INDESIT company

Model type:
AVF109SIT

Commercial code:
F033137

1140150B Exploded views

Fig . 001

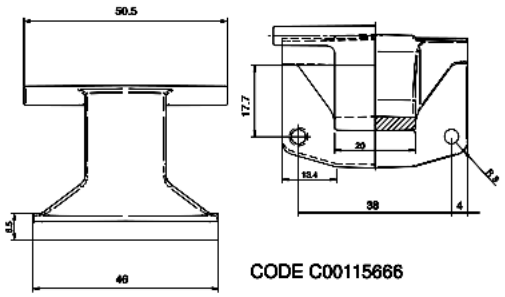
n1040349: Introduction of 150° Zamac hinge on Ariston 46 models.

From serial no. 50207.0001, all Ariston models produced in the Teverola factory (see table 001 attached) with industrial code (given on the rating plate) starting with 46, have been equipped with a Zamac hinge with 150° opening angle, code C00115666

(see Fig.001).
This modification has involved the introduction of the following items:

Code C00115670 - Complete door EVOII 150° white 27 with standard glass;
Code C00115674 - Complete door EVOII 150° white 27 with long glass;
Code C00115667 - EVOII body for 150° hinge white 27;

The premodified items are not interchangeable separately with the modified ones.

Code C00110133 - Complete door EVOII Standard 180° white 27 standard glass;
Code C00092157 - Complete door EVOII 180° white 27 long glass;
Code C00096193 - EVOII body for 150° hinge white 27;

The hinge code C00064541 continues to be used on the build-under models produced in the Comunanza factory.

Fig . 001

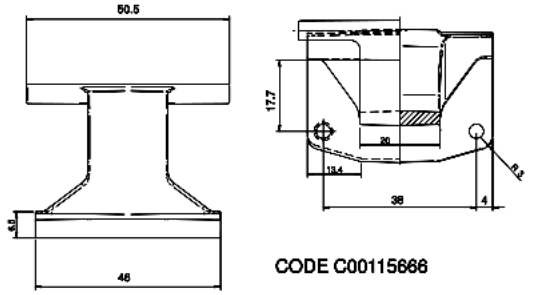
n1040353: Introduction of 150° Zamac hinge on Ariston models (Comunanza).

From serial no. 50207.0001, all Ariston models produced in the Comunanza factory (see table 001 attached) with industrial code (given on the rating plate) starting with 80, have been equipped with a Zamac hinge with 150° opening angle, code C00115666 (see Fig.001).
This modification has involved the introduction of the following items:

Code C00115670 - Complete door EVOII 150° white 27 with standard glass;
Code C00115674 - Complete door EVOII 150° white 27 with long glass;
Code C00115668 - Complete door EVOII 150° silver with standard glass;
Code C00115673 - Complete door EVOII 150° silver snella standard glass;
Code C00115662 - EVOII body for 150° hinge white 27
Code C00115663 - EVOII body for 150° hinge silver 27
Code C00115664 - Snella EVOII body for 150° hinge white 27
Code C00115665 - Snella EVOII body for 150° hinge silver

The premodified items are not interchangeable separately with the modified ones.

Code C00096416 - Complete door EVOII LB 180° standard depth silver;
Code C00097374 - Complete door EVOII 180° WD 180° white 27 long glass;
Code C00110133 - Complete door EVOII Standard 180° white 27
Code C00110178 - Complete door EVOII Snella 180° Silver;
Code C00091836 - EVOII body white 27 for 180° hinge;
Code C00094306 - EVOII body silver for 180° hinge;
Code C00094305 - Snella EVOII body white 27 for 180° hinge;
Code C00094307 - Snella EVOII body silver for 180° hinge;

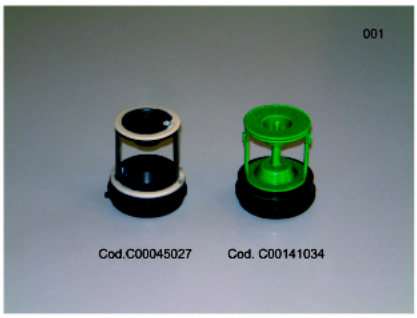
n1040378: 3.5 three phase module, factory 80 (Comunanza)

From October 2005, the new 3.5 module has been installed on three phase Comunanza models (80)

New parts:
C00254298 - Three phase module for card LB-WD 3.5;
C00141769 - J10-MV J16-EVA/NT WD cables (see picture attached).

Premodification parts:
C00257406 - MODULO WD>1200 G. +SC FW2.74 (CARD)
C00093717 - Cables J10-EWA MV NT WD.

The new items are not interchangeable with the premodification ones.
